Access Compliance Report

Public Rights-of-Way

Intersection ID: 50517	Main Street: STEWART TERRACE WY	Cross Street: MICHAEL CROSSING DR	Location: W
ADA ID: 845DEDBA3D96	Ramp Type: PerpDiag	Initial Pass/Fail: Fail	Overall Compliance: No
Severity Score: 13.75			
Codes/Mitigation Info/Possible Solution		Field Measurements/Component Compliance

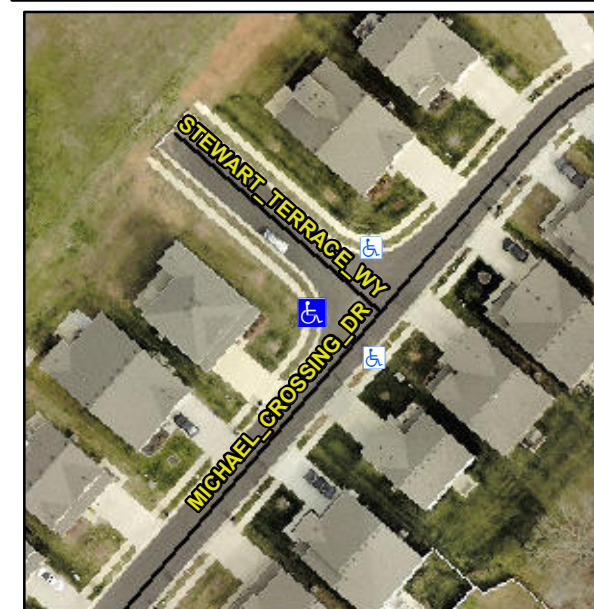
Not Found, R304.2.2, R304.5.3

Compliance	Description	Data	Compliance	Description	Data
N/A	Ramp Length (in)	48.0	No	Ramp Slope (%)	10.0
Yes	Ramp Width (in)	48.0	No	Ramp XSlope (%)	3.4
N/A	Flare Type LT	N/A	N/A	Flare Type RT	N/A
N/A	Flare Slope LT (%)	N/A	N/A	Flare Slope RT (%)	N/A
N/A	Flare Traversable LT?	N/A	N/A	Flare Traversable RT?	N/A
N/A	Landing Length (in)	N/A	N/A	DWS Provided?	N/A
N/A	Landing Width (in)	N/A	N/A	DWS Contrast?	N/A
N/A	Landing Slope (%)	N/A	N/A	DWS Length (in)	N/A
N/A	Landing X Slope (%)	N/A	N/A	DWS Full Width?	N/A
N/A	Landing Curb? (Y/N)	N/A	N/A	DWS Offset (in)	N/A
N/A	Shared Landing?	N/A			
N/A	Gutter Ponding?	N/A	N/A	Gutter Slope (%)	N/A
N/A	Gutter Lip Ht (in)	1.5	N/A	Gutter X Slope (%)	N/A
N/A	Painted X Walk1?	No	N/A	Painted X Walk2?	No
	X Walk 1 Direction	To SE		X Walk 2 Direction	To NE
N/A	X Walk 1 Width (in)	N/A	N/A	X Walk 2 Width (in)	N/A
	X Walk 1 Slope (%)	1.5		X Walk 2 Slope (%)	0.2
	X Walk 1 X Slope (%)	1.8		X Walk 2 X Slope (%)	2.9

Remove & Replace Curb Ramp With Two New Directional Ramps or Equivalent.
